**Request for City Council Committee Action
from the Department of Community Planning and Economic Development –
Planning Division**

Subject: Appeal of the City Planning Commission's decisions regarding land use applications at 100 Washington Avenue South: (1) Appeal of a condition of approval for a variance of the plaza development standards to reduce the required amount of seating; (2) Appeal of the conditions of approval for a site plan review application, specifically those conditions related to screening of the parking area; and (3) Appeal of the denial of a variance of the maximum size of a freestanding sign.

**APPEAL OF THE DECISION OF THE PLANNING COMMISSION
100 WASHINGTON SQUARE ADDITION AND PLAZA IMPROVEMENTS**

Property Location: 100 Washington Avenue South
Project Name: 100 Washington Square Addition and Plaza Improvements
Prepared By: [Lisa Steiner](#), City Planner, (612) 673-3950
Applicant: Shorenstein Realty Services
Project Contact: Jason Stiefel, Shea Architects
Request: To enclose a portion of the existing open-air first floor, reconstruct the plaza area, and install a new sign.

BUILDING SIGN AREA = 60 SF. FINAL SIZE PENDING VARIANCE APPROVAL FROM PLANNING DEPARTMENT.

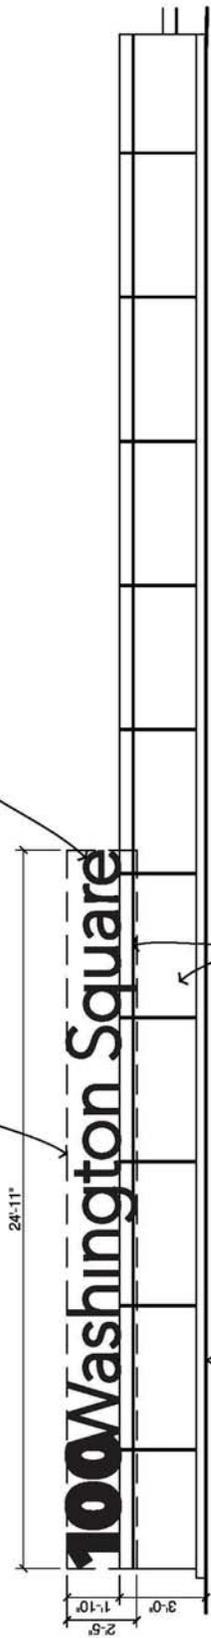
2. **Approve a modified request for a sign area variance to allow a freestanding monument sign of 60 square feet. An elevation and rendering of the proposed 60-square foot sign is attached.**

The original request was for a variance to allow a 120-square foot sign. Although the maximum area of a monument sign allowed by the zoning code is 32 square feet, the modified 60-square foot sign is reasonable in light of the 2.5 acre size of the parcel and size of the building. The reduced size of the proposed sign is similar to or smaller than other monument signs associated with large buildings in the Downtown for which the City has approved variances, including signs for Ameriprise (194 SF), Accenture Tower (82 SF), and Downtown East.

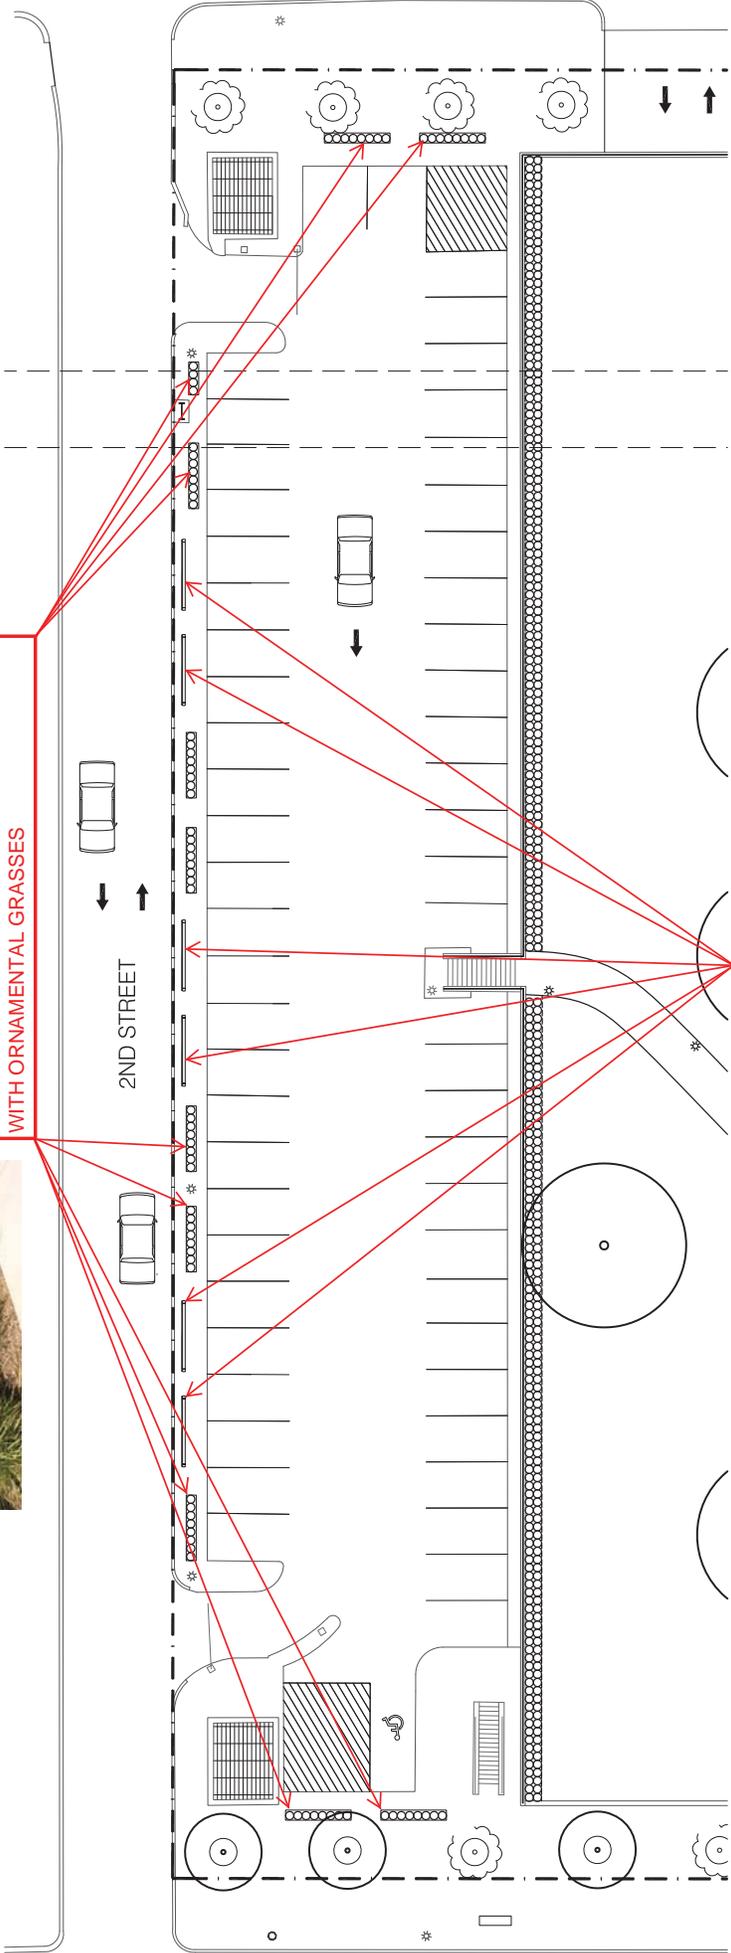
EXISTING GUARDRAILS REMOVED & REPLACED WITH NEW GALVANIZED STEEL PLANTER BOXES WITH ORNAMENTAL GRASSES

PERFORATED STEEL SCREEN PANELS ADDED TO EXISTING GUARDRAILS

1-1/2"x1-1/2" PAINTED HSS FRAME WITH PERFORATED PANEL INFILL. BOLTED TO EXISTING STEEL FRAME RAILING.

ARCHITECTURAL
SITE PLAN

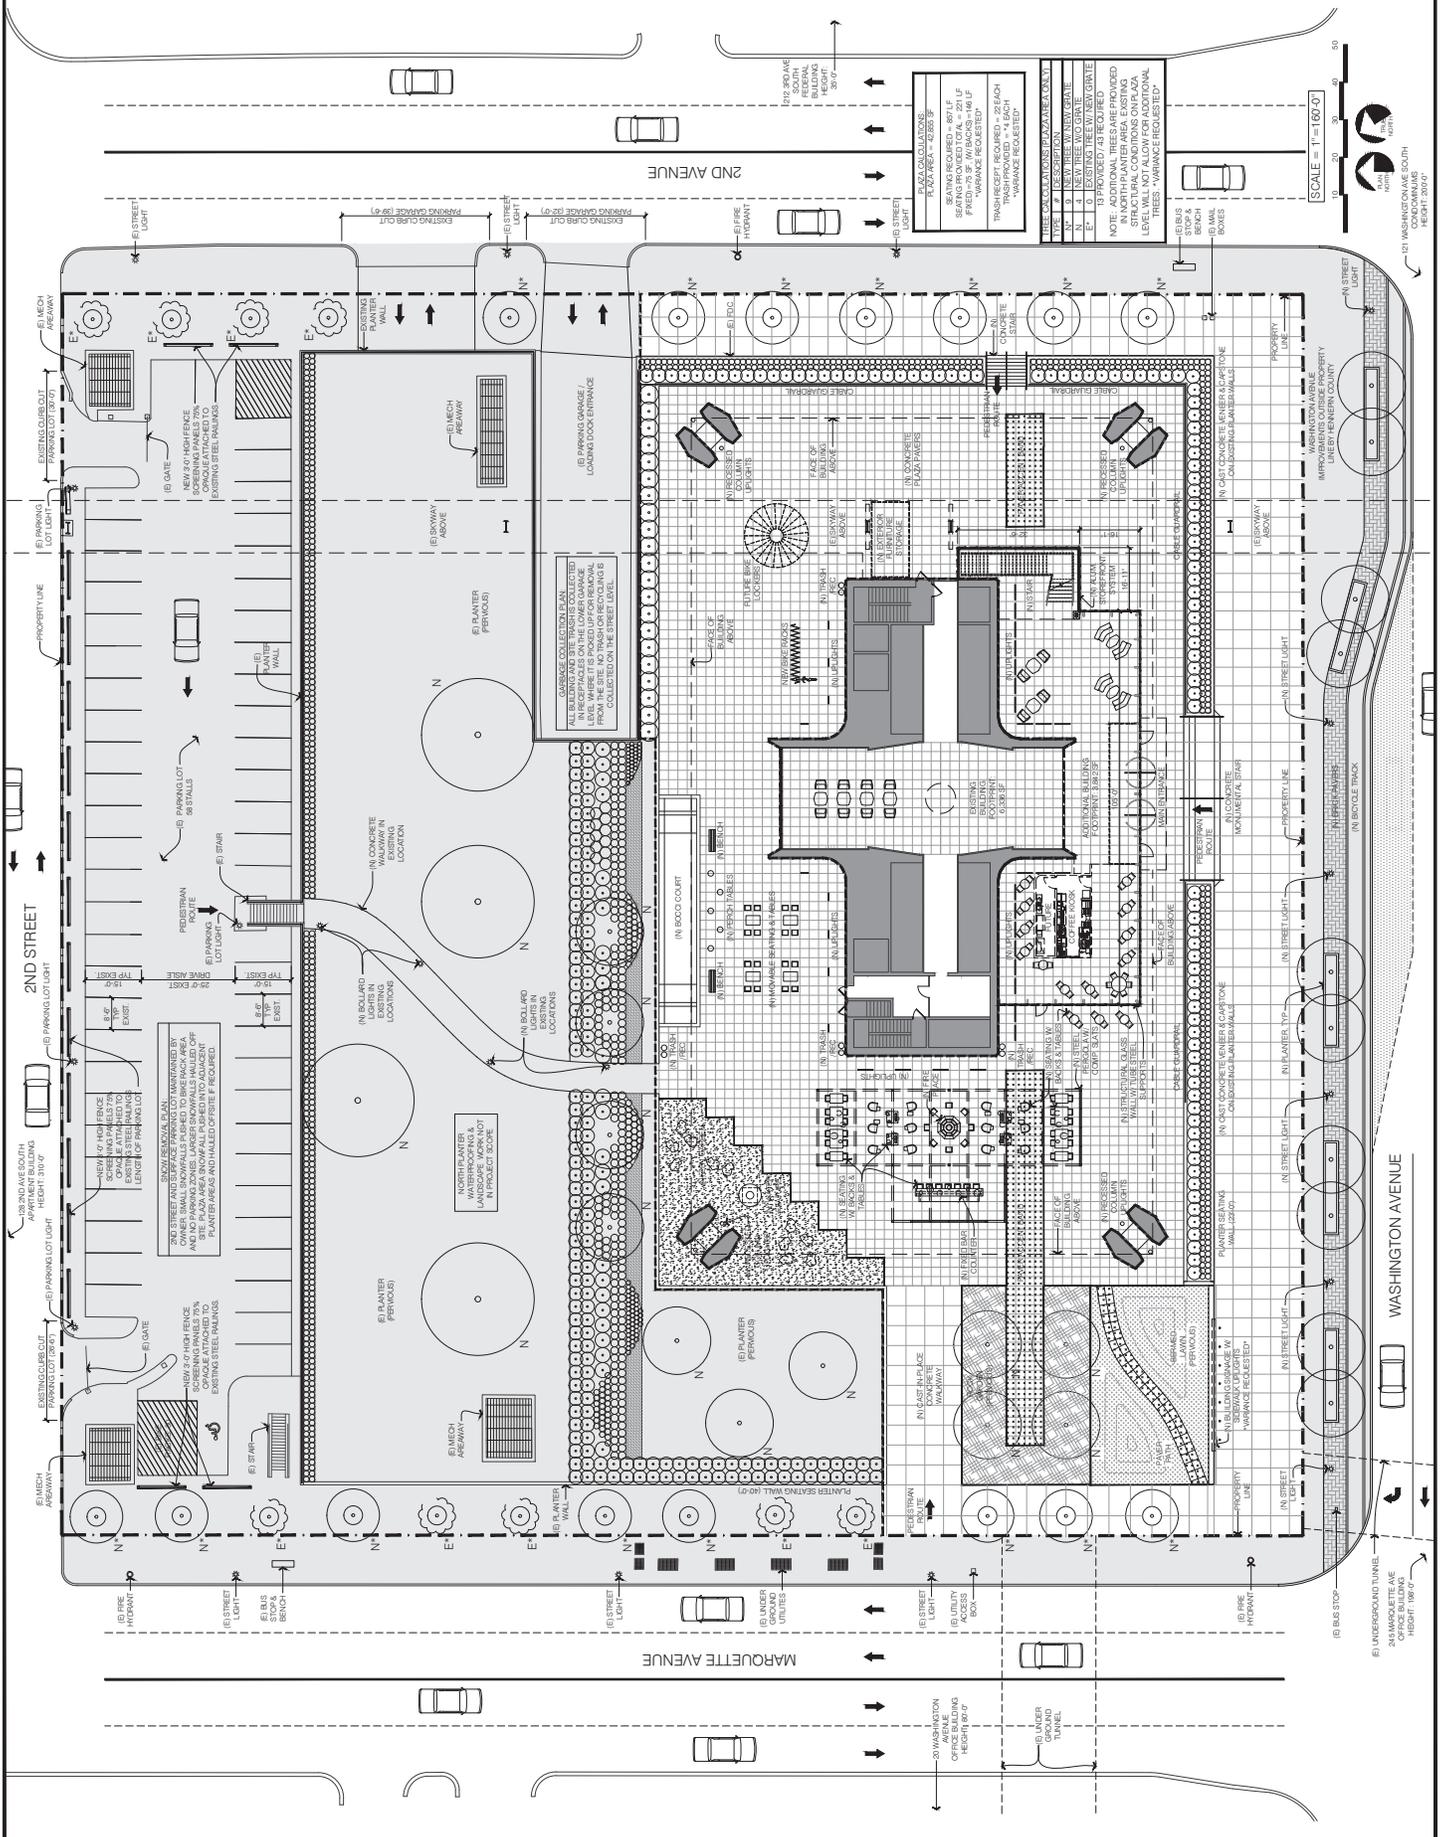
- Stormwater Management: Please clearly identify the disturbed area associated with the proposed project. The Civil and Surface Plan Note #1 on Sheet C1 indicates a disturbance of 0.98 acres, however it appears that an area greater than this is proposed to be disturbed. It is unclear what the 0.98 acres refers to. The property line on Sheet C1 also does not appear to be accurately depicted.

311 SERIES

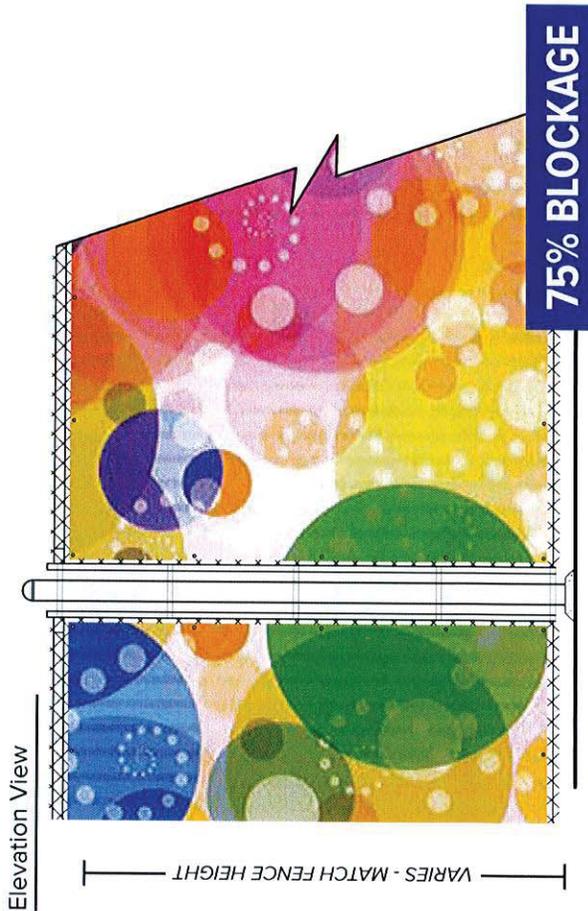
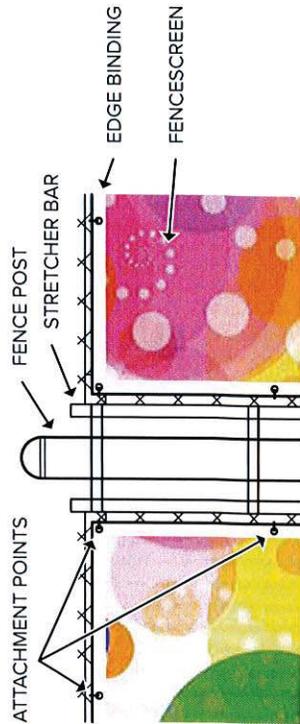
This material is not durable and would not be considered to be a “masonry wall, fence, berm or hedge or combination thereof” as required by the site plan review standards. This type of material merely gives a false impression of landscaping, is more suited to temporary construction site screening, and does not meet the intent of the ordinance. Also, per section 535.430 of the zoning code, fences shall be constructed of wood, metal, bricks, masonry or other permanent materials designed for permanent fencing. The vinyl mesh banner proposed does not meet the requirements for fencing material.
